Product Change Notification: E-21-001601

PLUG ASSY, 0.6mm PITCH CHAMP DOCKING CONNECTOR, 40 POS

Docking Plug 2129261-1 EC

Existing

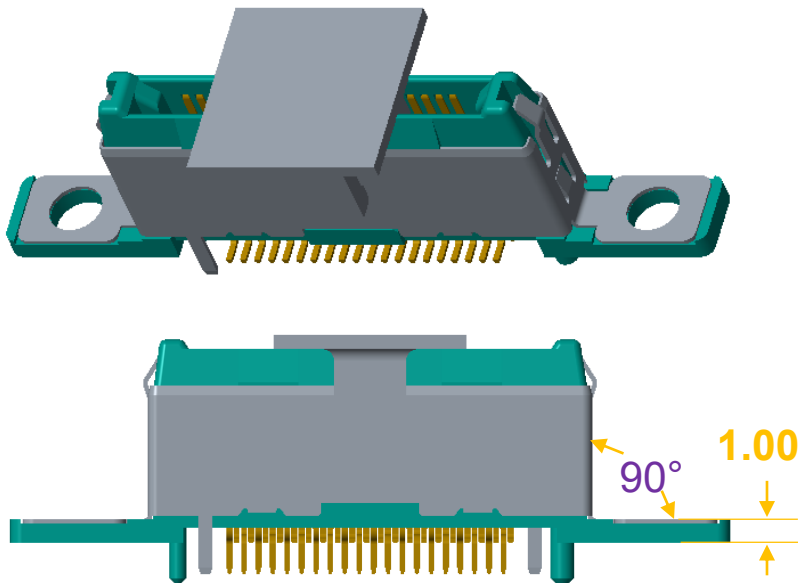
Shell EC change:

The only difference between existing and new is the bending angle of the side flanges.
